**BEFORE THE UNITED STATES  
NUCLEAR REGULATORY COMMISSION**

In the Matter of	)	
SOUTHERN CALIFORNIA EDISON COMPANY	)	Docket Nos.
(San Onofre Nuclear Generating Station)	)	San Onofre 50-361 and 50-362-LA
	)	November 16, 2012
	)

**CITIZENS OVERSIGHT'S ANSWER TO SUBMISSIONS BY NRC STAFF AND SOUTHERN CALIFORNIA EDISON OPPOSING THE PETITION TO INTERVENE AND REQUEST FOR A HEARING BY CITIZENS OVERSIGHT.**

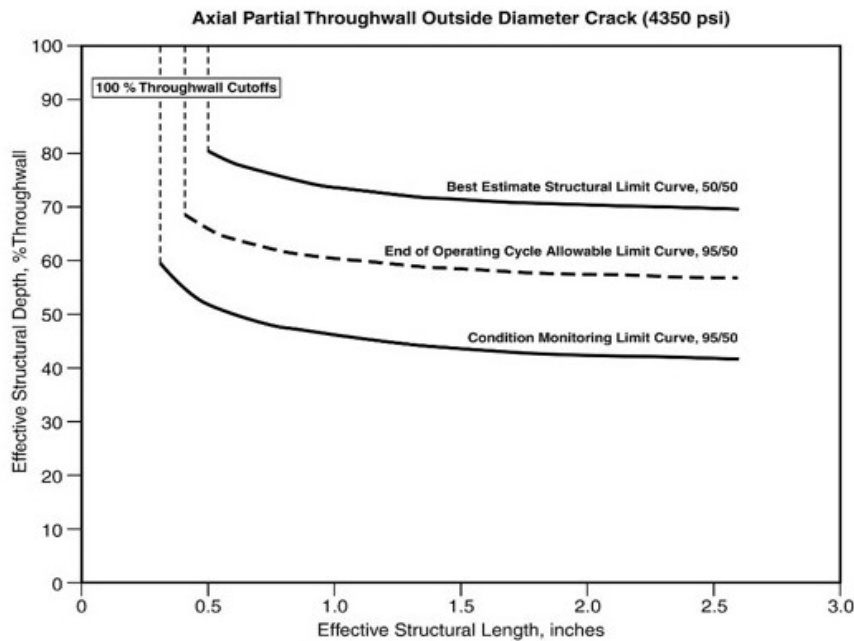
in December 2009, compiles burst test data, mathematical degradation models, and defined burst pressure equations to guide users in assessing specific modes of degradation relative to current industry experience. Degradation mechanisms addressed include fatigue, stress corrosion cracking, denting, fretting, wear, and intergranular attack. The handbook is used for developing flawed tubing structural limits, such as those shown in the accompanying figure, which are essential in informing integrity assessments.

Throughout these documents, 100% wear of the tube (i.e. a leak) means that the tube no longer has structural integrity. In the diagram above, in no case is 100% structural depth wear considered structurally sound. The requirement that "All in-service steam generator tubes shall retain structural integrity over the full range of normal operating conditions"<sup>12</sup> also means that there can be no leakage due to degradation mechanisms, such as "fatigue, stress corrosion cracking, denting, fretting, wear, and intergranular attack"<sup>13</sup>
